Form 3160-5
(June 2019)UNITED STATES
DEPARTMENT OF THE INTERIOR
BUREAU OF LAND MANAGEMENTFORM APPROVED
OMB No. 1004-0137
Expires: October 31, 2021**SUNDRY NOTICES AND REPORTS ON WELLS**
**Do not use this form for proposals to drill or to re-enter an
abandoned well. Use Form 3160-3 (APD) for such proposals.**

8. Well Name and No. ROSEMARY 10 FED COM/704H

9. API Well No. 30-015-47682

EOG respectfully requests an amendment to our approved APD for this well to reflect the following changes:

Revised Wellbore

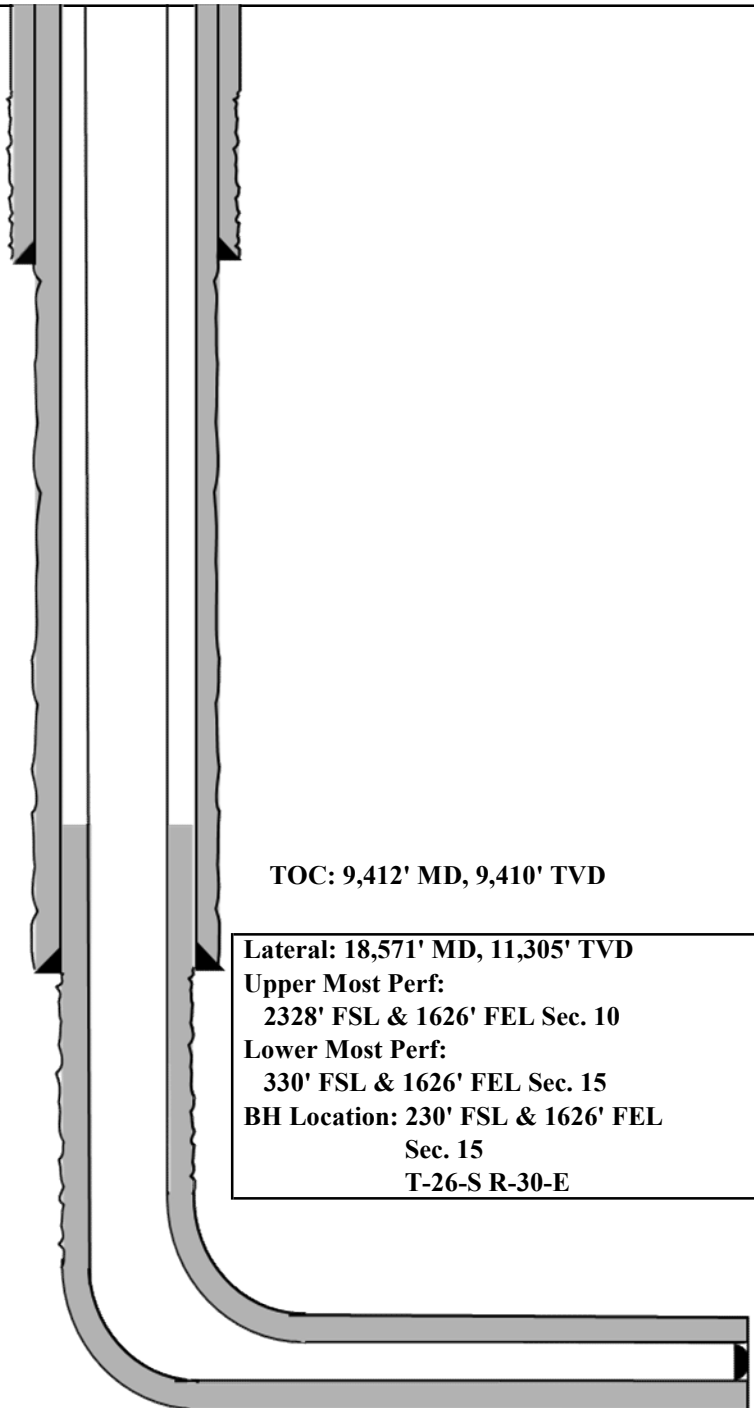
Change name from Rosemary 10 Fed Com 704H to Rosemary 10 Fed Com 724H.

Change BHL from T-26-S, R-30-E, Sec 15, 230' FSL, 1310' FEL, Eddy Co., NM,
to T-26-S, R-30-E, Sec 15, 230' FSL, 1626' FEL, Eddy Co., N.M.

Change target formation to Wolfcamp U2.

Update casing and cement program to current design.

Bit Size: 12-1/4"
9-5/8", 36#, J-55, LTC,
@ 0' - 1,160'

Bit Size: 8-3/4"
7-5/8", 29.7#, HCP-110, FXL,
@ 0' - 9,912'

Bit Size: 6-3/4"
5-1/2", 20#, P110-EC, DWC/C IS MS,
@ 0' - 9,412'
5-1/2", 20#, P110-EC, Vam Sprint SF,
@ 9,412' - 9,912'
5-1/2", 20#, P110-EC, DWC/C IS MS,
@ 9,912' - 18,571'

Lateral: 18,571' MD, 11,305' TVD
Upper Most Perf:
2328' FSL & 1626' FEL Sec. 10
Lower Most Perf:
330' FSL & 1626' FEL Sec. 15
BH Location: 230' FSL & 1626' FEL
Sec. 15
T-26-S R-30-E

Proposed Wellbore

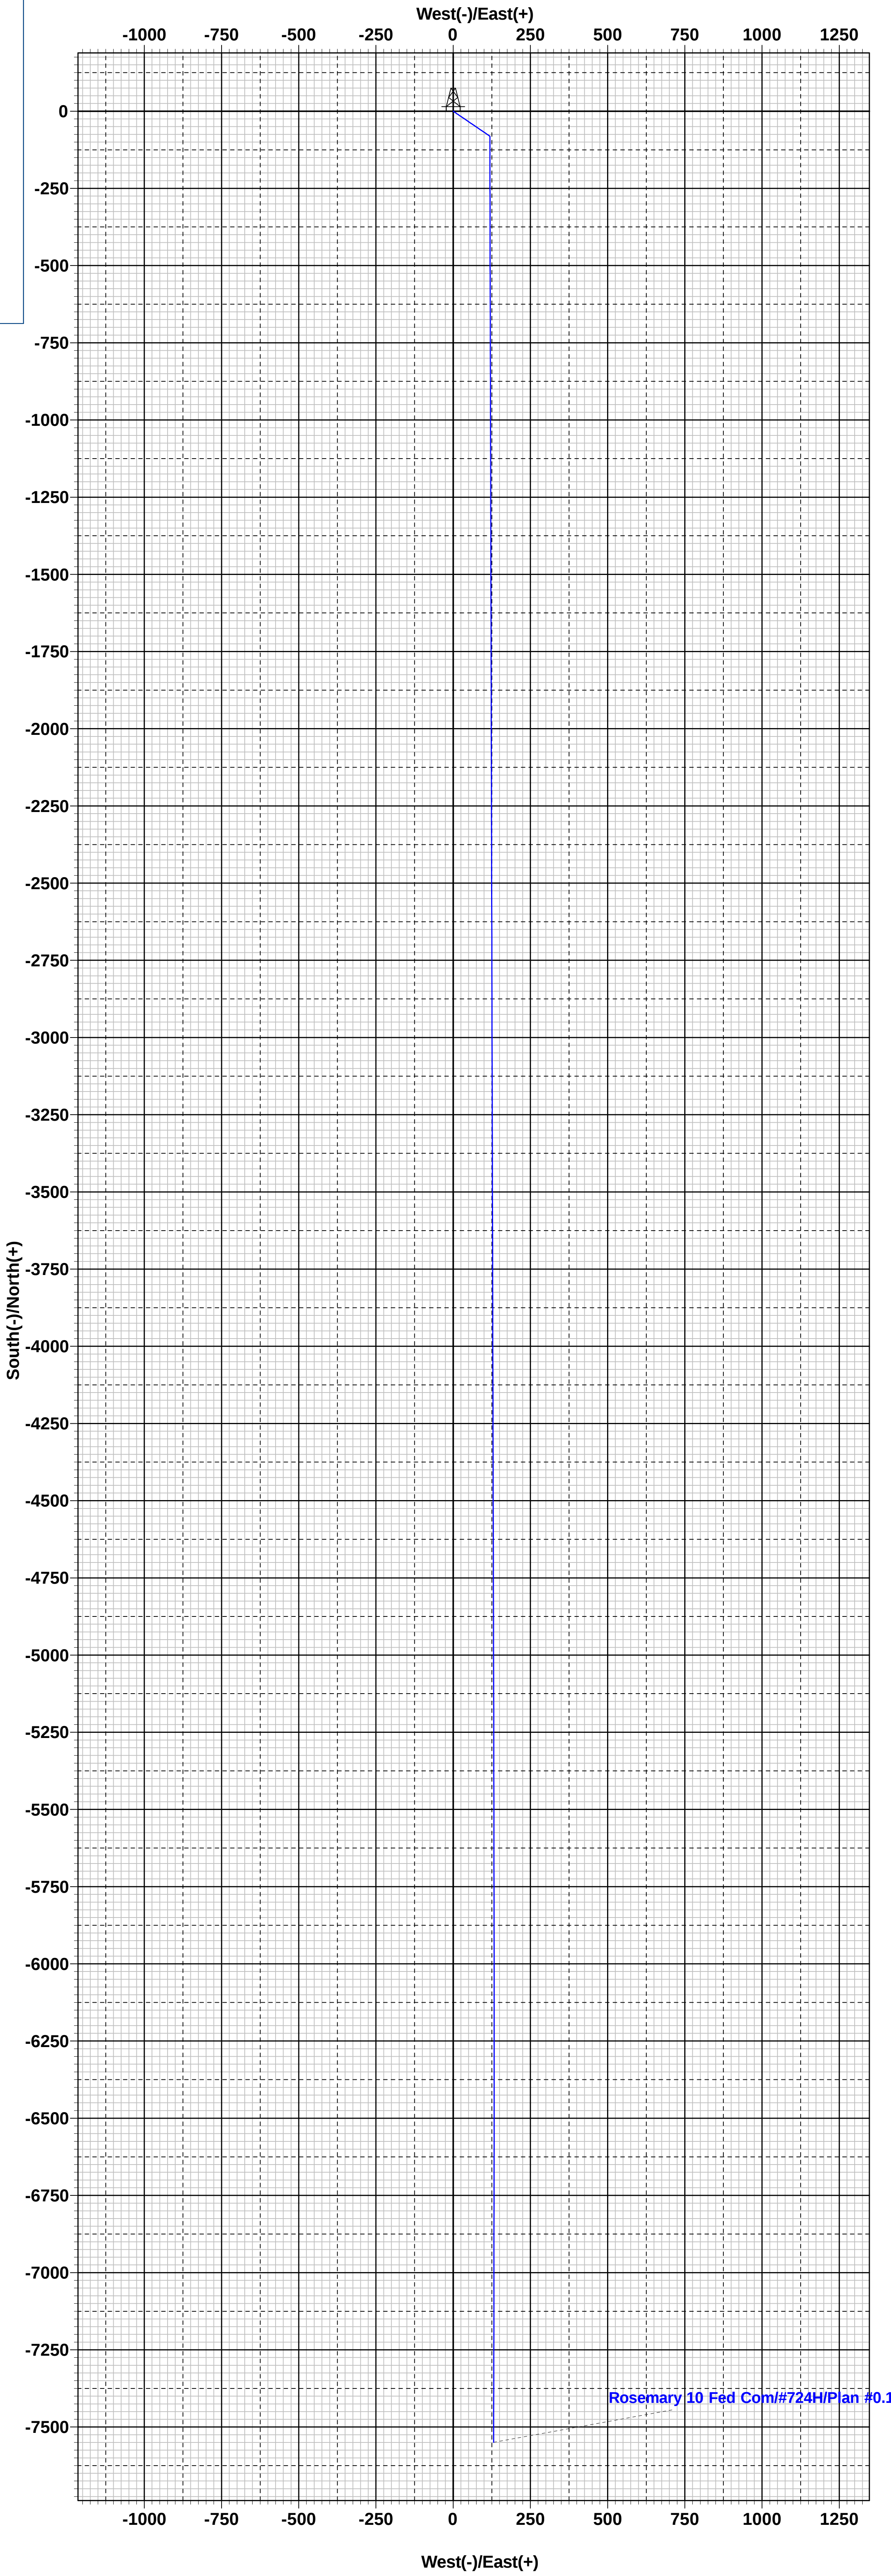
Design B**4. CASING PROGRAM**

Bit Size: 13"
10-3/4", 40.5#, J-55, STC,
@ 0' - 1,160'

Bit Size: 9-7/8"
8-3/4" 38.5#, P110-EC, SLIJ II NA,
@ 0' - 9,912'

Bit Size: 7-7/8"
6", 22.3#, P110-EC, DWC/C IS,
@ 0' - 18,571'

Lateral: 18,571' MD, 11,305' TVD
Upper Most Perf:
2328' FSL & 1626' FEL Sec. 10
Lower Most Perf:
330' FSL & 1626' FEL Sec. 15
BH Location: 230' FSL & 1626' FEL
Sec. 15
T-26-S R-30-E
